# Technical Bulletin

Bulletin No: TCH-002-008

## Subject: New Bendix® “Welded Clevis” Spring Brake Chamber

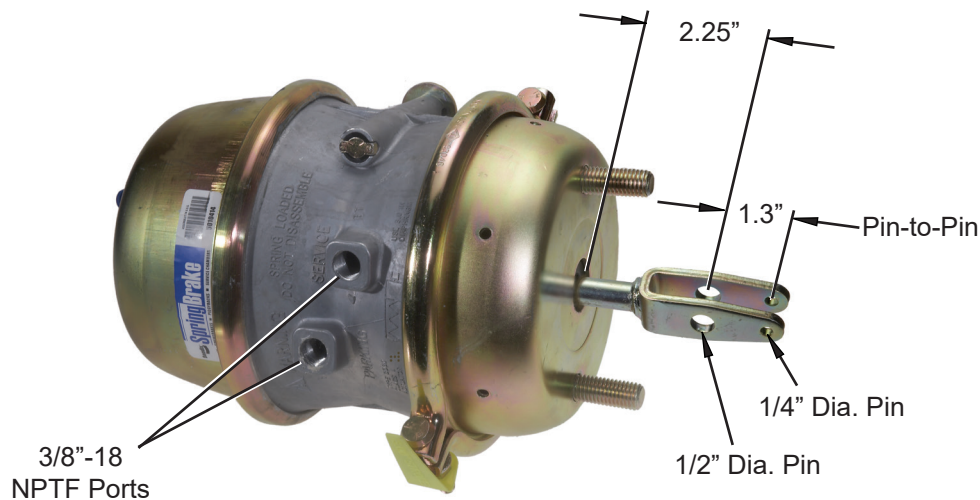
Bendix Commercial Vehicle Systems LLC now offers spring brake chambers with a welded automatic slack adjuster clevis. Many OEM's are using welded clevis spring brake chambers in production to reduce installation time and to accommodate certain applications. Now the dependable and reliable Bendix® SB-4™ spring brake chambers are available to the Aftermarket for these applications with the time saving welded clevis.

Note: The 1.3 inch pin-to-pin dimension on the welded clevis allows it to be used with single and double clevis pin slack adjusters in applications requiring the dimensions shown here. The Bendix® ASA-5® Slack Adjuster requires a clevis pin-to-pin dimension of 1.0 inch; therefore, it can not be used with the spring brake chambers shown here.
